LYNX HARDWARE CHANGE IMPACT ANALYSIS (HCIA) FOR POWER AMPLIFIER & RF SWITCH UPDATES

CAGE Code 1WYD3	Initial Release Date 07-Mar-2019	Revision Date 27-Aug-2019	Document Number 8210332-001	Revision A
----------------------------------	---	--	--	-----------------------------

Doc Number 8210332-001	Lynx Hardware Change Impact Analysis (HCIA) For the Power Amplifier & RF Switch Updates	Revision A
---------------------------	--	---------------

Figure 2-1: Power Amplifier Schematic Excerpt

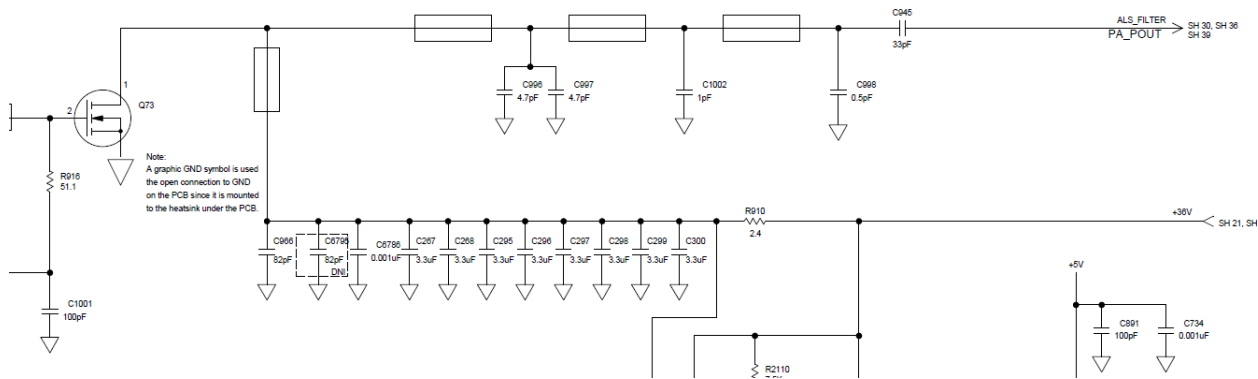
The update to the RF amplifier is accomplished by revising the 9001305 document to include the 9001305-002 component. The 9020020-003 CCA is then updated to use the 9001305-002 (STAC1011-350B). The reference designator (Q73) and all assembly notes remain unchanged, only the parts list is affected.

The power amplifier, Q73, provides the final amplification of modulated 1030MHz and 1090MHz, TAS and Transponder signals, to either the top or bottom antennas via PIN diode switches. The amplifier, shown in schematic excerpt Figure 2-1, and does not result in any additional component changes or modifications.

STMicroelectronics Inc. provided information about the package changes as well as early issues with oscillations in a document titled "STAC1011-350A Package Update5.pdf", which is archived with this document within AIM. Subsequently, STMicroelectronics provided environmental performance test data on the updated component that included temperature, vibration, and shock testing on multiple samples in the document "STAC1011-350B-STAC780-Final Reliability Report.pdf" which is also archived with this document in AIM.

ACSS performed temperature testing using a hold-down mechanism which facilitated testing multiple amplifiers. Since solder was not involved, the hold-down mounting allowed the devices to oscillate. However, when mounted flush and with good CCA contact, the amplifiers met power and pulse fidelity requirements over temperature. Test data describing these tests and the results are included with this document in AIM in the document "Final Report on MLT PA Issues 2018.doc".

The mechanical differences between the packages have been compared with no significant issues found. The dimension differences are shown in the included document "NGT-9000 PA 9001305-001 Package Dimension Differences.xlsx".

Figure 2-2: Schematic Excerpt, Transmitter Self-test Signal Routing

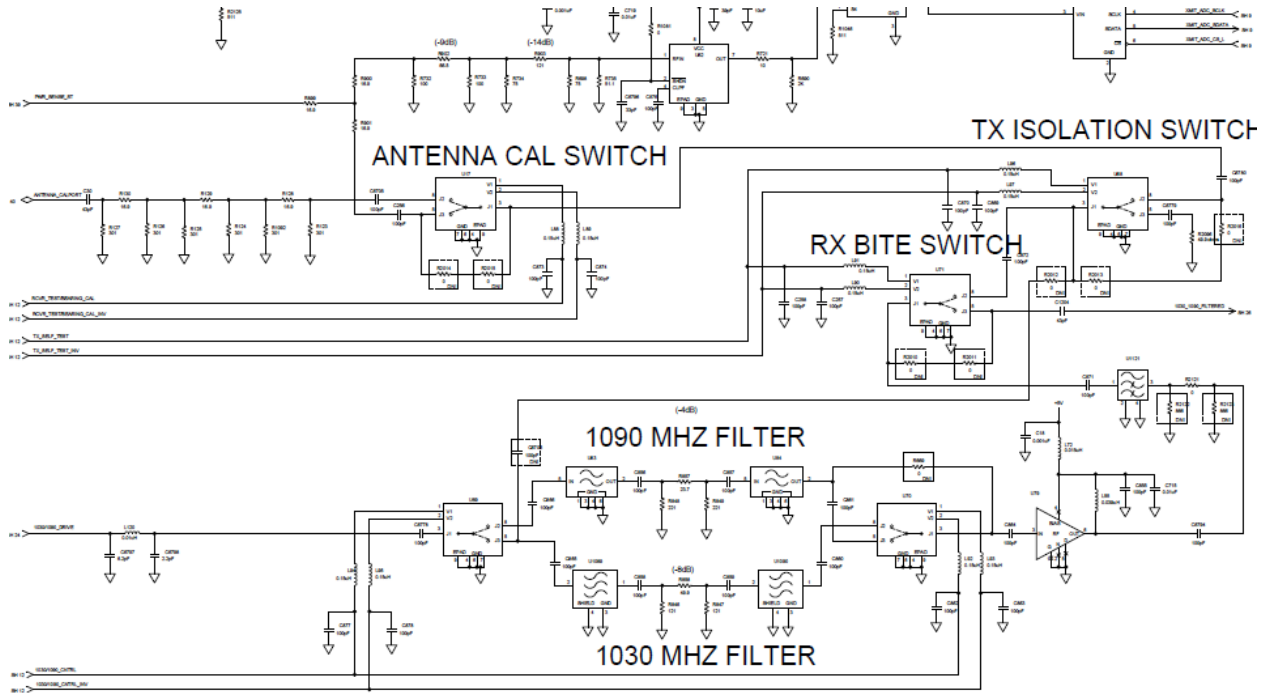
U69 and U70, as shown in Figure 2-2, direct small signal RF to either the 1030MHz or 1090MHz bandpass filters. These signals may be used for self-calibration, self-test, or for amplification and transmission depending on the state as controlled by the FPGA. Key characteristics for each switch are greater than 20dB isolation between the selected and unselected switch outputs so as to meet spectral mask requirements (40dBc) and switching times less than 600ns to support DO-181E transponder reply delay requirements.

U71 selects directing the filtered small signal RF to either be amplified for transmission or used for either calibration or self-test. In LRUs without the TAS function enabled, the switch may be bypassed by the resistors shown in the dashed-line squares because the 1030MHz transmissions are not needed. The key characteristic for the switch are greater than 20dB isolation between the selected and unselected switch output.

U68 directs self-test and calibration signals to either a 50ohm resistor or U17, the antenna Cal switch. The key characteristic for the switch is isolation greater than 20dB, as this switch assists in preventing undesired coupling to and from antenna ports.

The schematic excerpts for these switches are shown in both Figure 2-2 and Figure 2-3.

Figure 2-3: Schematic Excerpt, Transmitter Feedback or Receiver Self-test

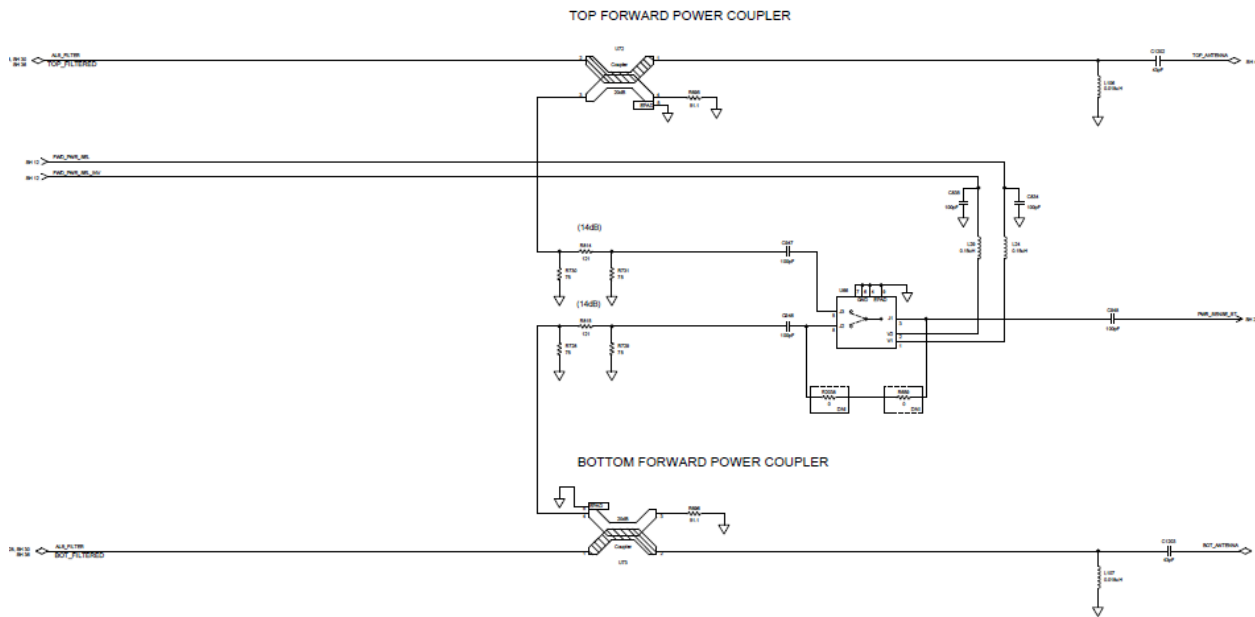
U17 both isolates the self-test and transmitter filtering circuitry from the transmitter feedback signal while transmitting as well as directing the self-test signals between the antenna calibration port or to the receiver self-test switch. The key characteristics for the switch is isolation greater than 20dB.

The self-test switch, U66, directs the receiver self-test signals to either the top or the bottom antenna inputs or, when transmitting, directs the transmitter forward power feedback signal from the correct antenna. The key characteristic is switch isolation greater than 20dB to ensure that the correct top/bottom path is used for both self-test and transmitter feedback.
